Subject: DDMI Response to MVEIRB Supplemental Information Request#5 for the Environmental Assessment of the Processed Kimberlite to Mine Workings Proposal (MVEIRB File No.: EA1819-01)

Processed Kimberlite to Mine Workings

**Response to Supplemental Information Request#5
from the Mackenzie Valley Environmental Impact
Review Board**

Document #: ENVI-988-0819 R0

Figure 1. Predicted TDS Concentrations with no connection to Lac de Gras (left) compared with the SIS prediction with a full connection (right)

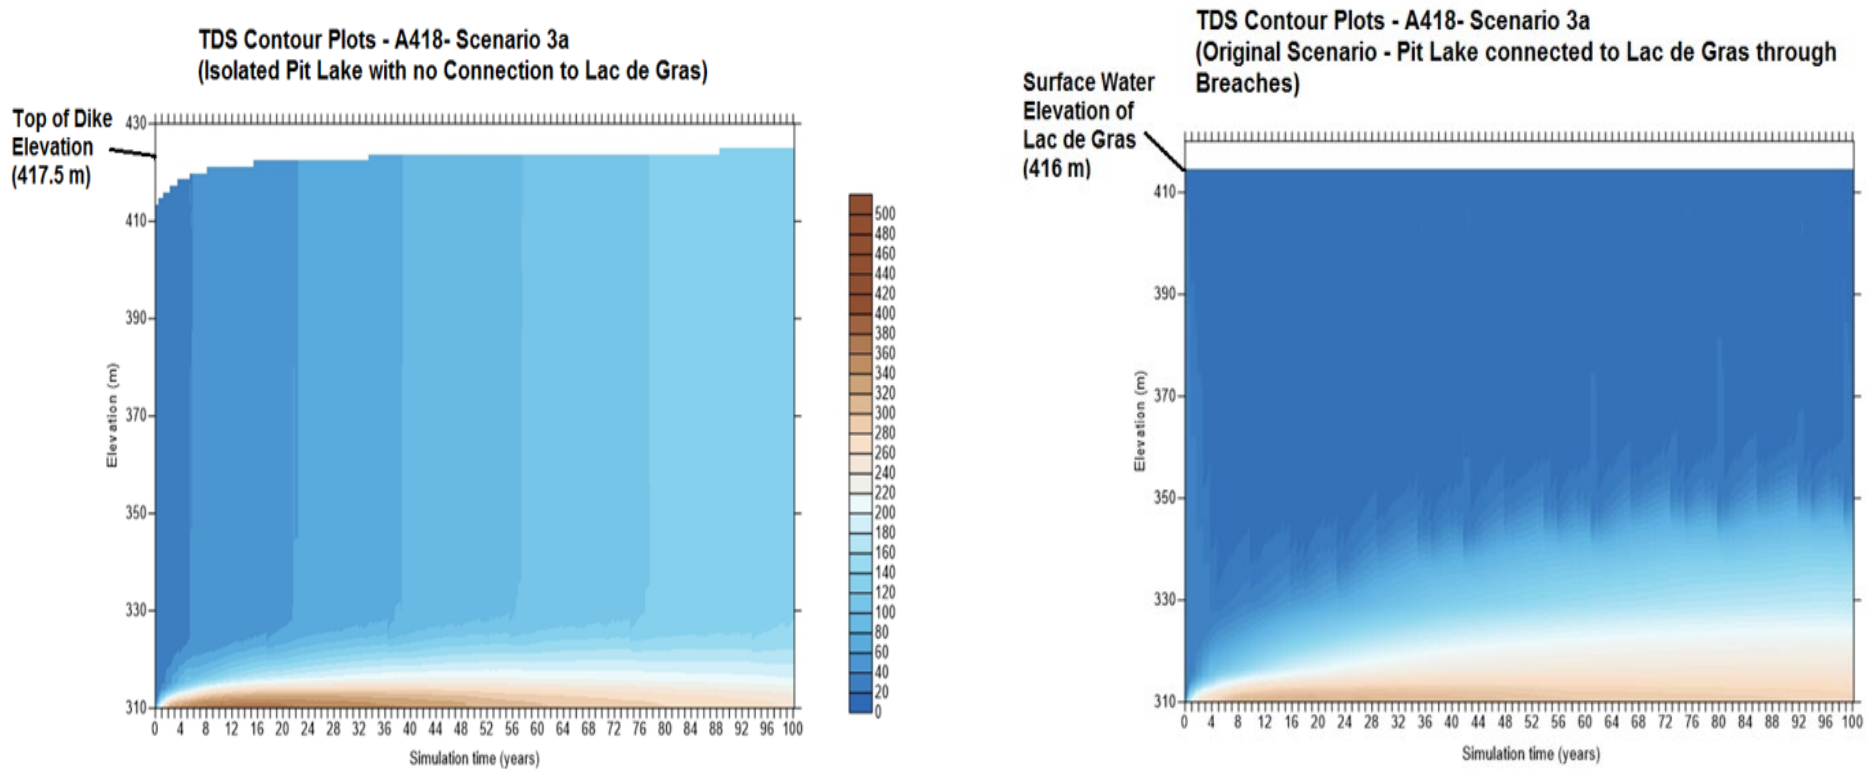
Scenario 1: pit lake remains completely isolated from Lac de Gras (that is, no water flows between the pit lake and Lac de Gras).

- a) long term water quality modelling results (from closure until pit lake water quality stabilizes). Include modelled maximum water quality concentrations in the pit lake at surface and 40 m depths, and describe when those maximums would occur.
- b) a description of how this would change the effects assessment provided in the *Summary Impact Statement*.

Figure 1 shows the model results for this isolation scenario as compared with the Summary Impact Statement (SIS) prediction Scenario 3a (where the pit lake is connected to Lac de Gras through breaches in the dikes (SIS, Appendix B, Figure B1).

As can be seen in Figure 1, under the “isolated pit lake scenario” stratification is weaker because there is no inflow from Lac de Gras to dilute the surface layers in the pit lake and create the density gradients that are the basis for meromixis. In this scenario there is greater vertical mixing and higher total dissolved solids (TDS) concentrations compared with the original reconnection scenario.
